Access Compliance Report Public Rights-of-Way (Curb Ramps)

Main Street: MERCANTILE_WAY Cross Street: WINDMILL_AVE Location: NE

ADA ID: RPRK211029114712 Ramp Type: Type 4 - Parallel Initial Pass/Fail: Fail Overall Compliance: No Severity Score: 45

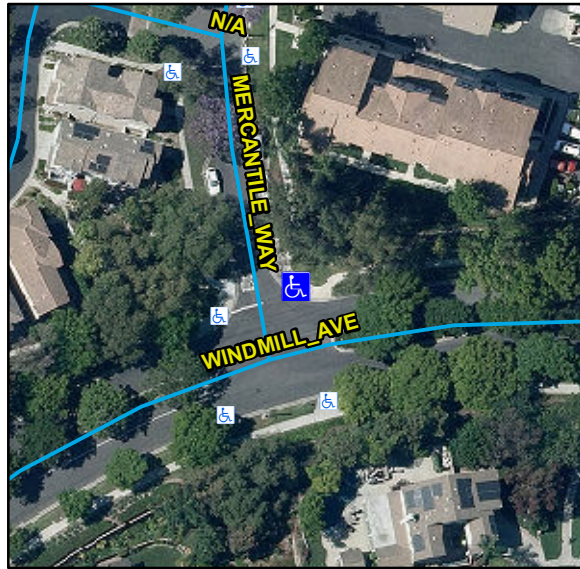
Compliance	Description	Data	Compliance	Description	Data
N/A	Ramp Length LT (in)	106	N/A	Ramp Length RT (in)	110
Yes	Ramp Width LT (in)	90	Yes	Ramp Width RT (in)	90
Yes	Ramp Run Slope LT (%)	2.7	No	Ramp Run Slope RT (%)	11.7
No	Ramp Cross Slope LT (%)	8	No	Ramp Cross Slope RT (%)	5.2
N/A	Landing Present	N/A	N/A	DWS Provided	N/A
N/A	Landing Length (in)	N/A	N/A	DWS Contrast	N/A
N/A	Landing Width (in)	N/A	N/A	DWS Length (in)	N/A
N/A	Landing Run Slope (%)	N/A	N/A	DWS Full Width	N/A
N/A	Landing Cross Slope (%)	N/A		DWS Offset Type	N/A
N/A	Landing Movement Obstructed?	N/A	N/A	DWS Offset Left (in)	N/A
	Landing Movement Type	N/A	N/A	DWS Offset Right (in)	N/A
N/A	Landing Shared	N/A			
N/A	Clear Space	Yes			
N/A	Clear Space To Crosswalk (in)	N/A			
N/A	Marked Crosswalk 1	No	N/A	Marked Crosswalk 2	No
	Crossing 1 Direction	W		Crossing 2 Direction	S
	Marked Crosswalk 1 Width (in)	N/A		Marked Crosswalk 2 Width (in)	N/A
N/A	Ramp Inside Crosswalk 1	N/A	N/A	Ramp Inside Crosswalk 2	N/A

Crossing 1 Slope (%)	2.4		Crossing 2 Slope (%)	1.9
	Crossing 1 Cross Slope (%)	3.3		Crossing 2 Cross Slope (%)	6.2
N/A	Gutter Ponding	N/A	N/A	Curb Slope	1.3
Yes	Gutter Lip Height (in)	0		Road Run Slope (%)	6.8
N/A	Gutter Run Slope (%)	N/A		Road Cross Slope (%)	3.7
N/A	Gutter Cross Slope (%)	N/A	No	Perpendicular Joint Present	No
Yes	Overall Surface Condition	Acceptable			
	Cross Gutter Present?	No		Spandrel Present?	No
	Replace Cross Gutter?	N/A		Replace Spandrel?	N/A

Remove & Replace Curb Ramp With Two New Directional Ramps or Equivalent.
